Schedule 17 Plans and Specifications Design and Access Statement Addendum- Adelaide Road Vent Shaft S1

Document no.: 1MCo3-SCJ_SDH-IM-STA-SSo2_SLo1-000001

1.3 Design Development - Northern Facade

North elevation - updated Schedule 17 submission

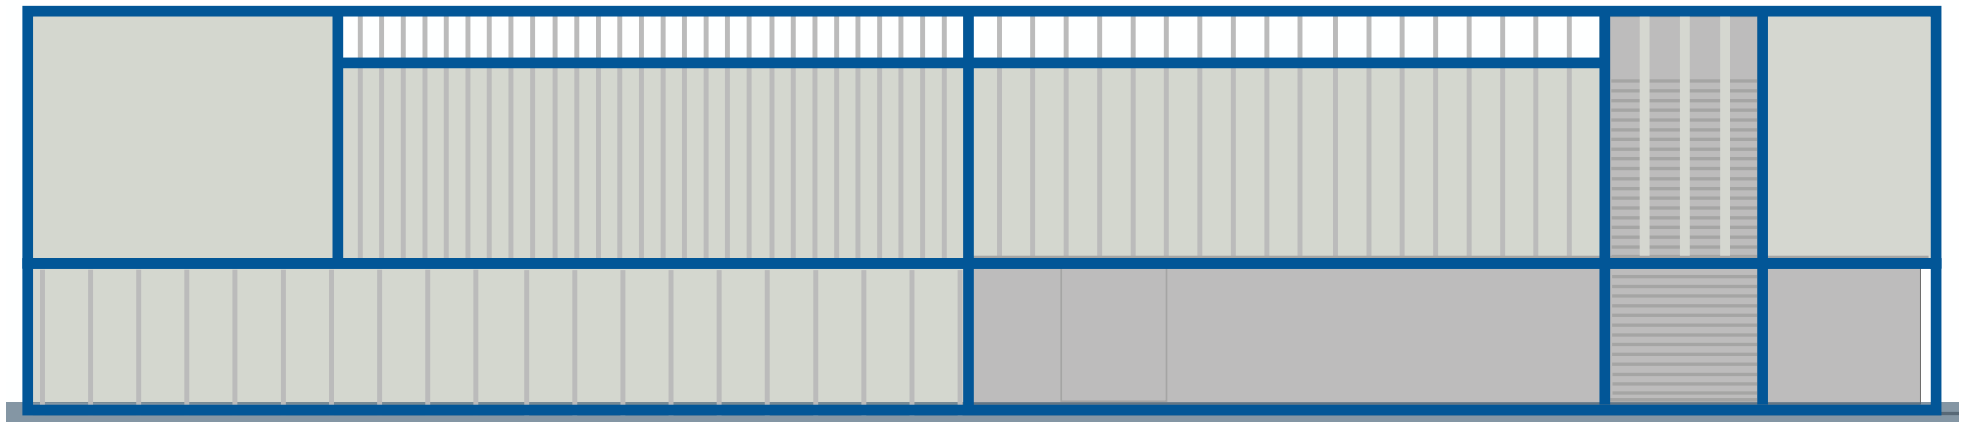
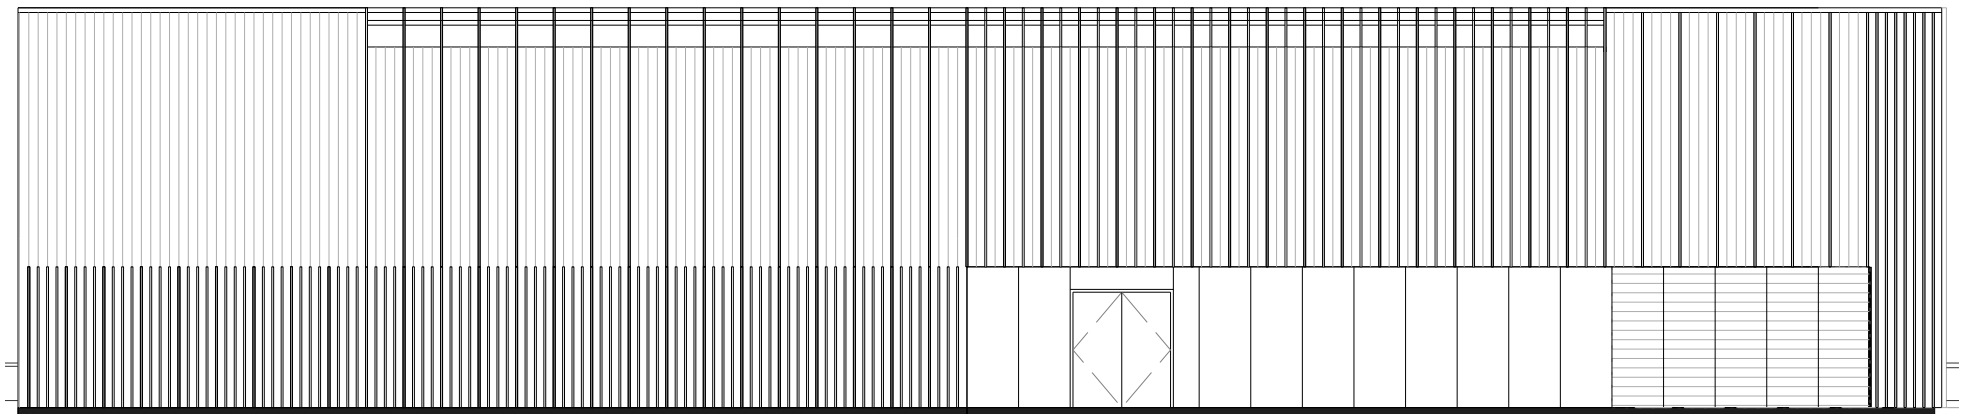
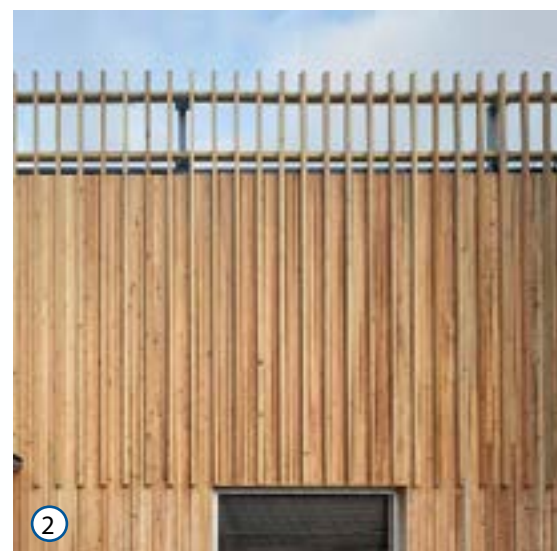
Several comments received about the previous design of the building related to how it responded to the local context, and to the general scale of the building.

To address comments about the building’s scale, several design tools have been implemented, namely:

- Dividing the facade into different zones to visually break up the elevation into smaller zones;
- Introducing textural relief into the facade by applying timber fins to the timber cladding;
- Lowering part of the solid parapet to visually reduce the perceived bulk of the building (see page 6 for details);
- Adding an area of treated (charred) timber cladding to provide a contrast between light and dark.

During the design development period, the engineers advised that louvres needed to be applied to part of the facade to allow ventilation for the equipment inside. These have been located towards the western end of the elevation at ground level, as seen in the lower right corner of the elevation. The louvres sit in an area of dark grey metal cladding and should be visually unobtrusive.

The design has applied a dark colour behind the timber fins at low level to zone the base of the building and kept this area of the facade to approximately one third of the overall building height. Retaining a one third / two third relationship between the building’s base and top helps to visually reduce the overall height.

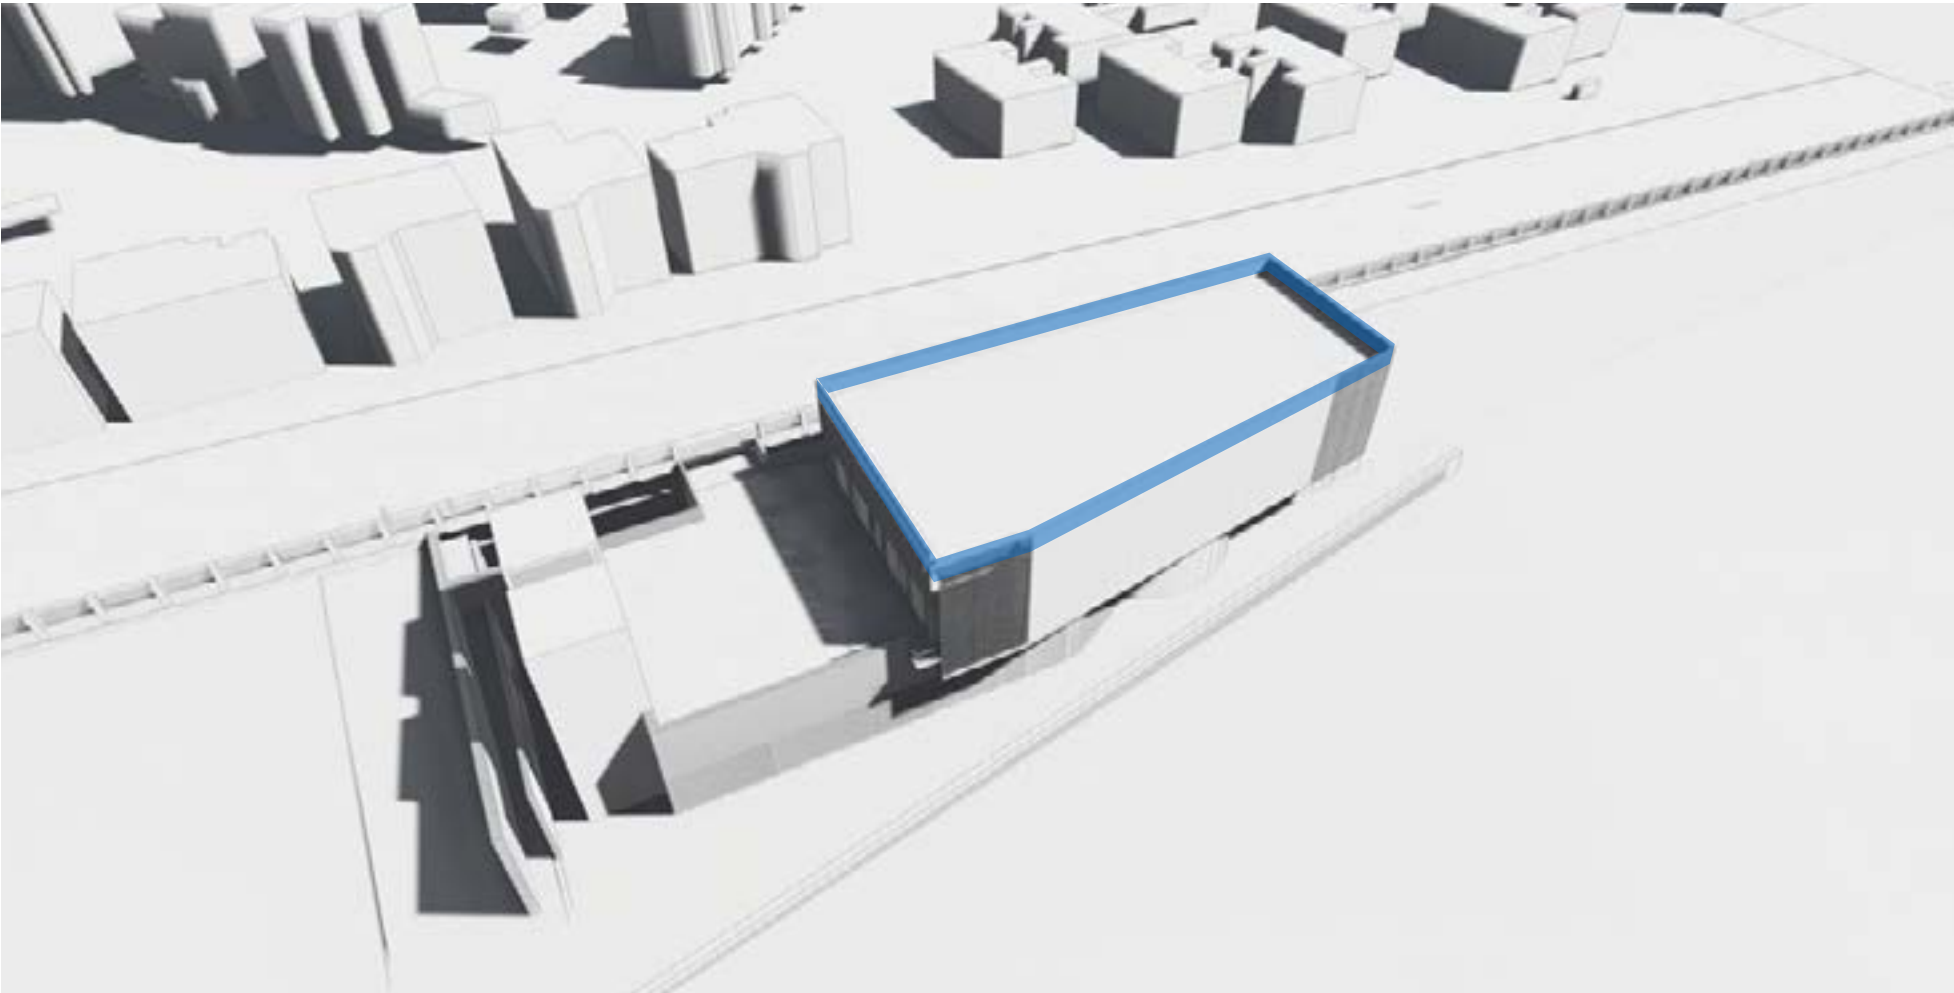
The parapet at the top of the building provides acoustic protection from the roof mounted equipment, and fall protection for people working on the roof maintaining the building and equipment. It also visually screens the roof top equipment. Comments were received about the amount of louvres on the north facade and the design team has addressed these comments by moving some of the louvred area onto the roof as part of an enclosure that sits behind and below the parapet, making the most of the parapet’s acoustic protection functionality.

In response to comments about the massing of the building the design team identified an area of parapet along the north elevation that could be lowered. It is not possible to reduce the level of the parapet around the whole building, but lowering this portion makes the building appear less tall and responds better to its context.

Providing a zone of lowered parapet reduces the visual impact of the building and the tall areas at both ends act as “bookends”, mirroring the language of the buildings across the street. The design team discussed this approach at length with LB Camden during a series of workshops and the proposal illustrated adjacent was developed. The adjacent sketch shows a glazed balustrade in blue, for illustrative purposes only, and the actual glass will be clear, not coloured, allowing views of the sky through the balustrade.

Indicative view of building from north west corner

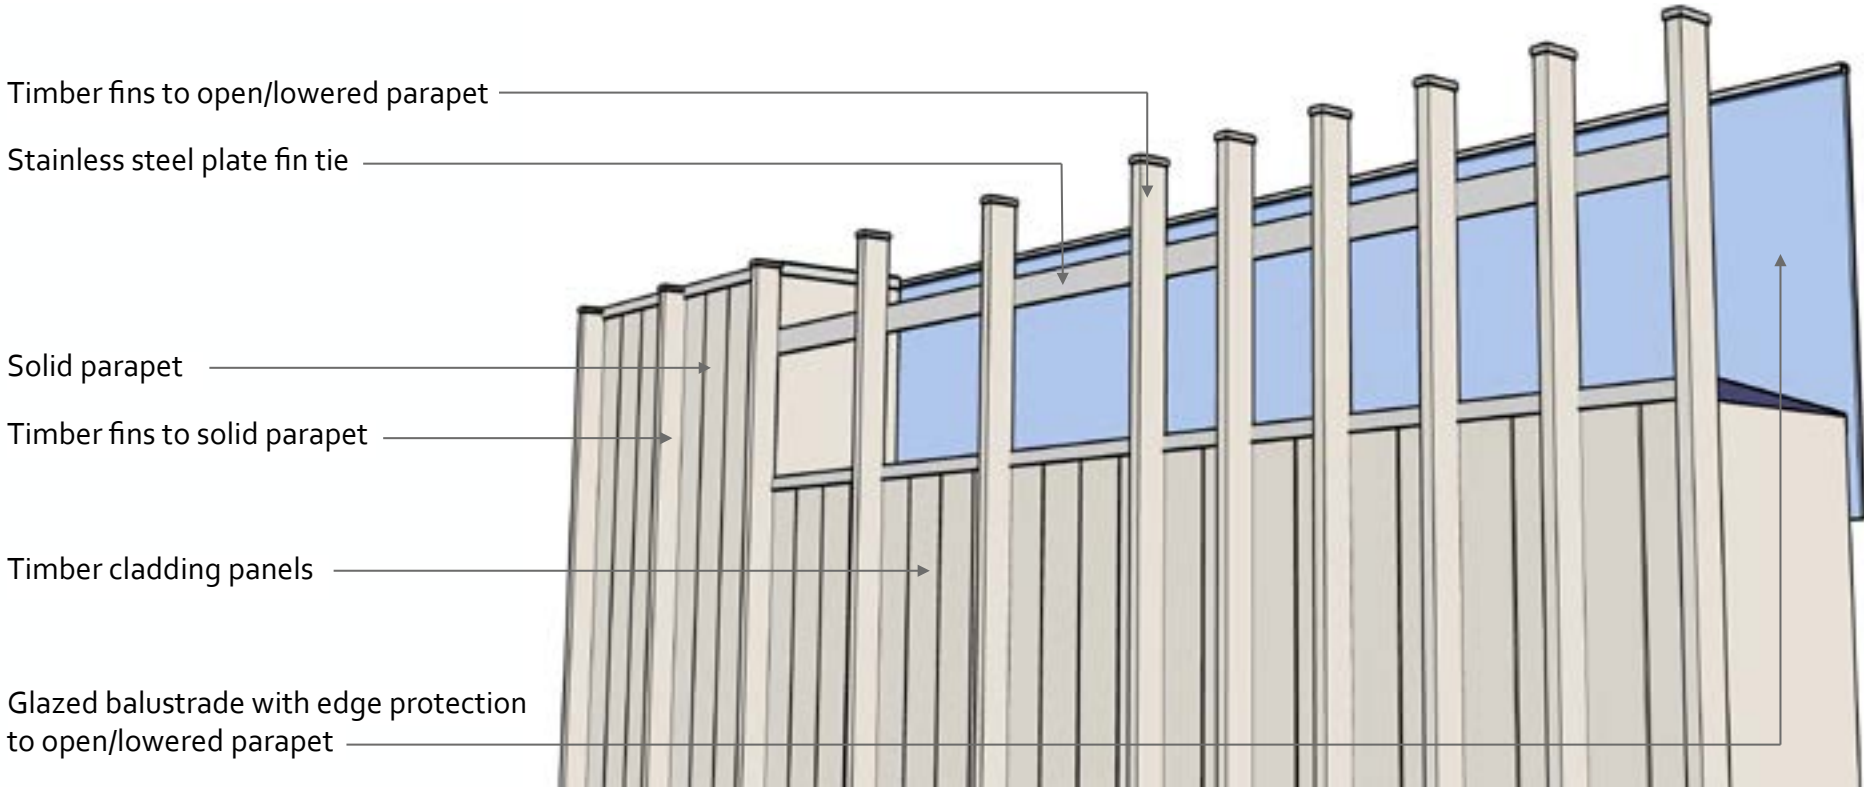
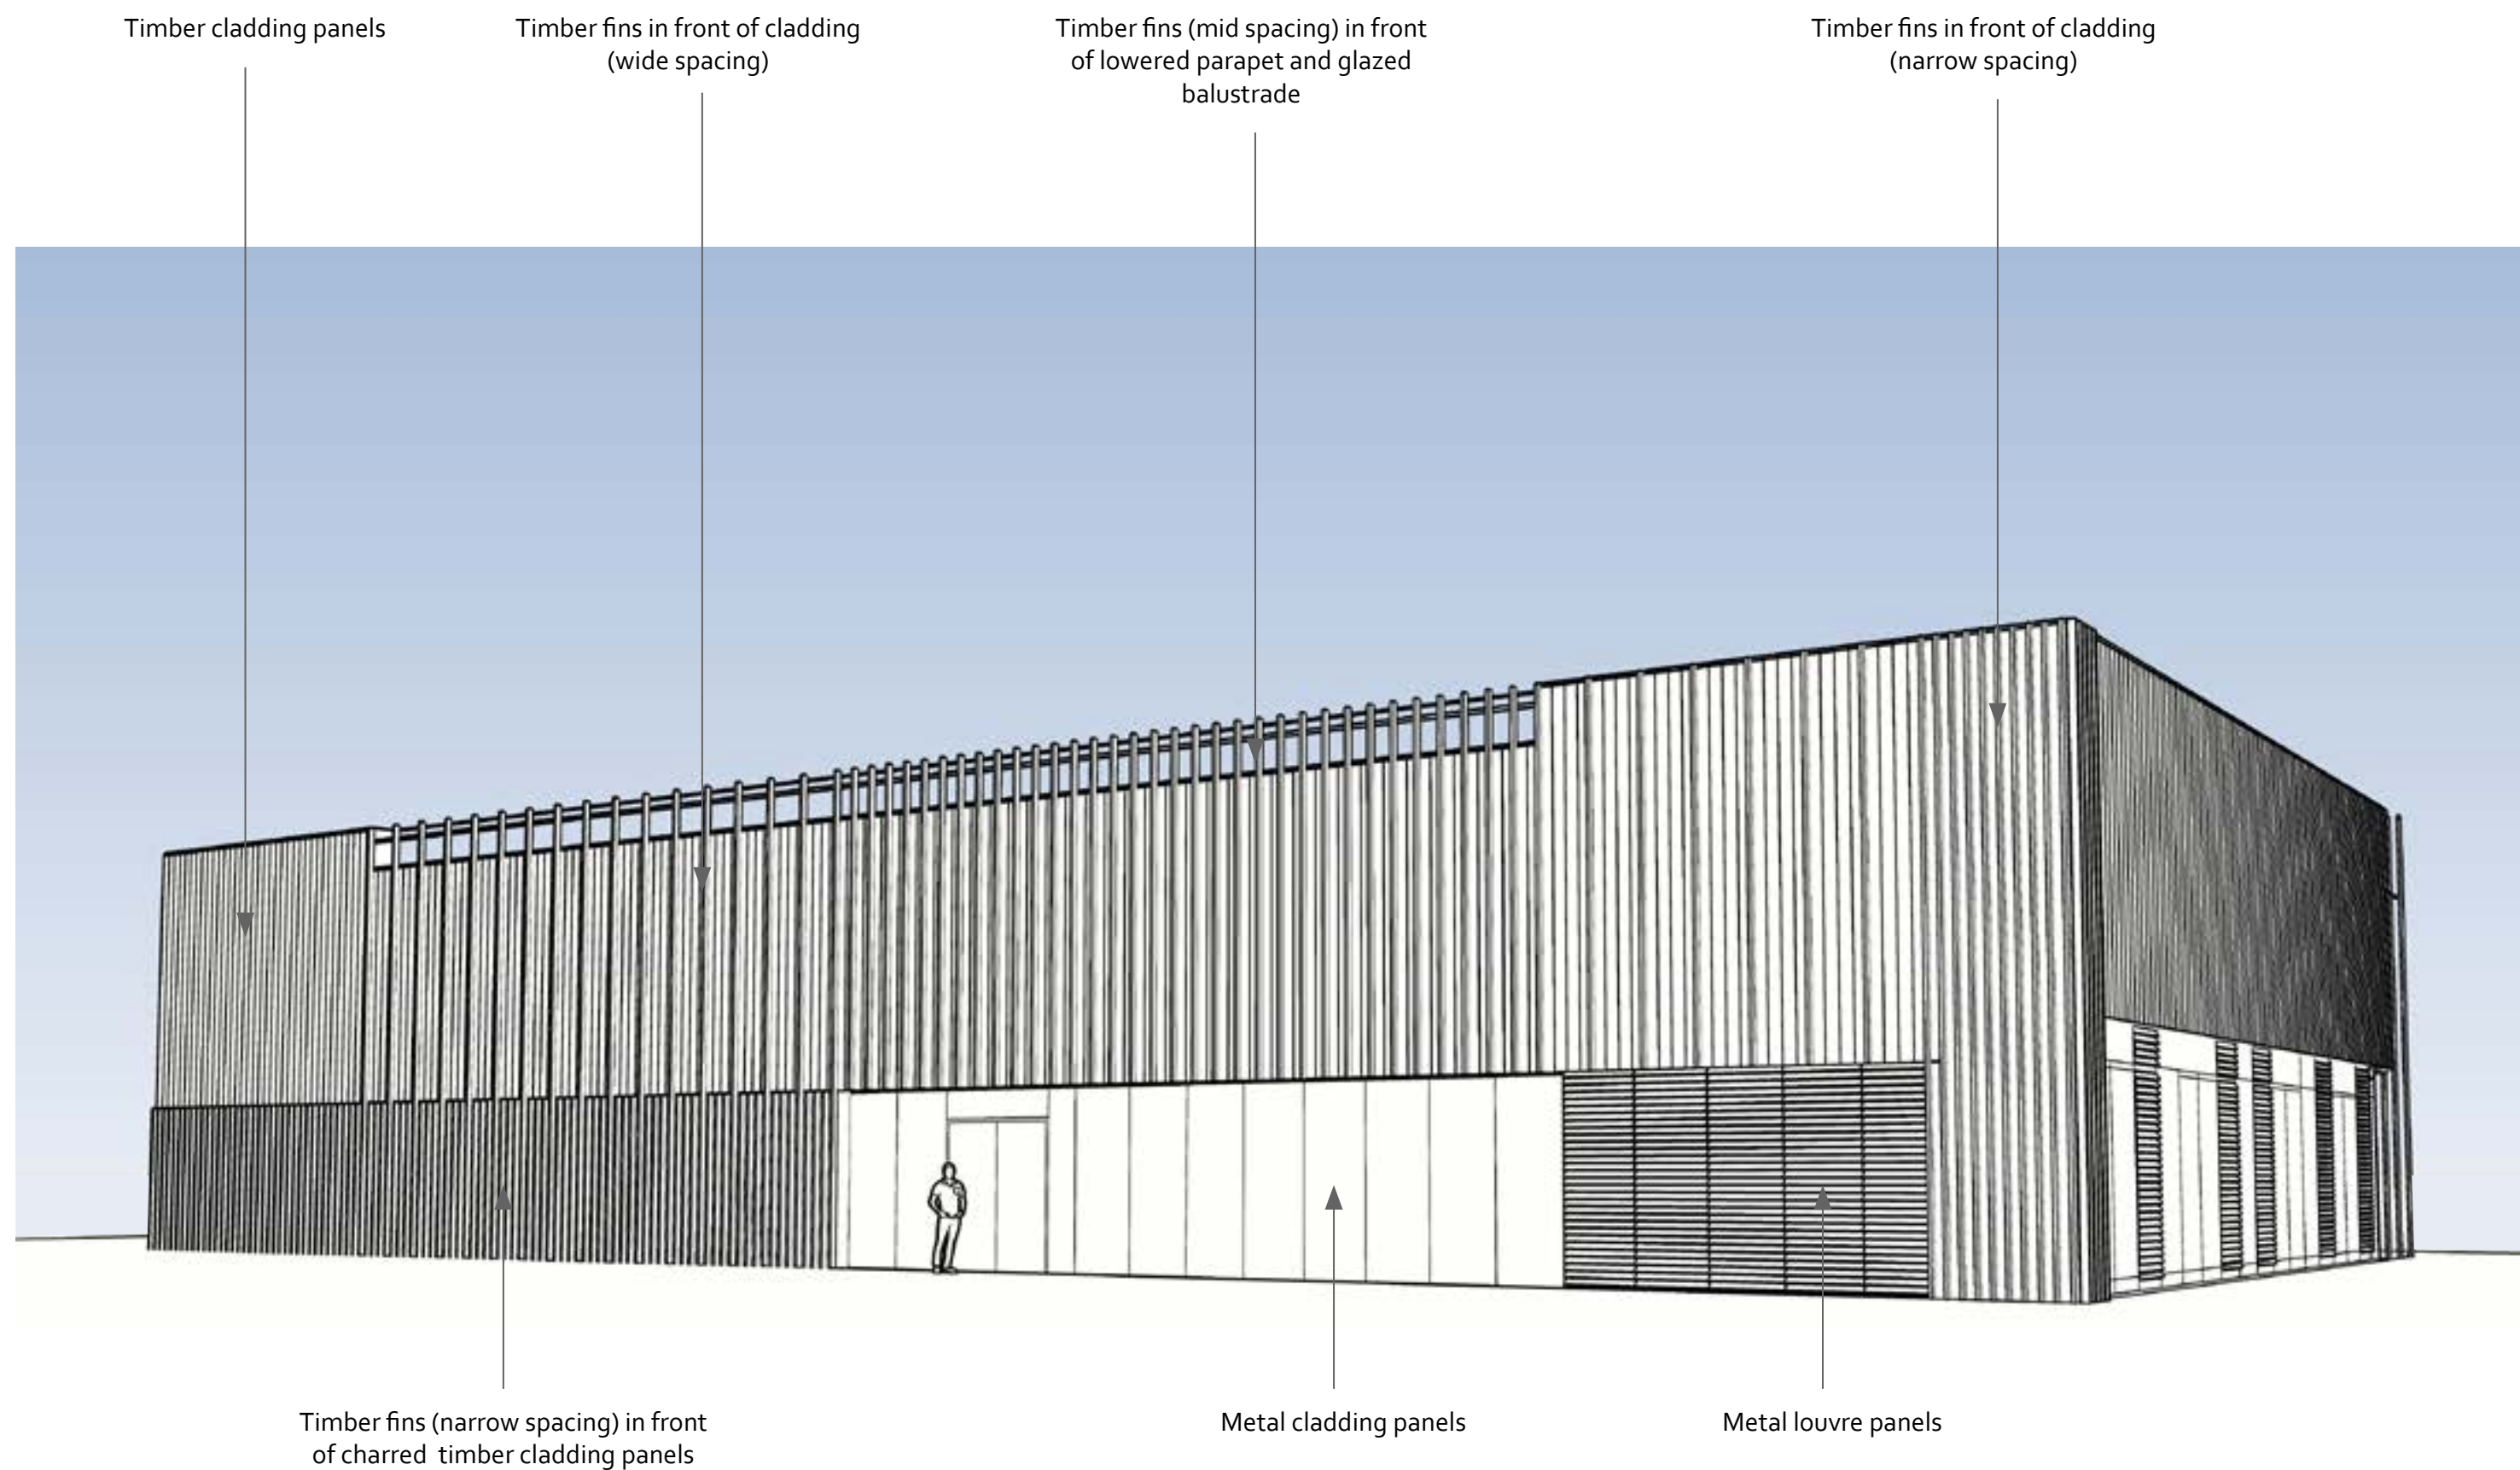
Where the parapet has been reduced in height a glazed balustrade has been installed behind the timber fins. This glazed area protects neighbours from rooftop generated noise and provides edge protection for maintainers. Having the timber fins extend past the level of the lowered parapet gives the building a feathered edge detail that softens the edge of the building, similar to some of the precedent images earlier.
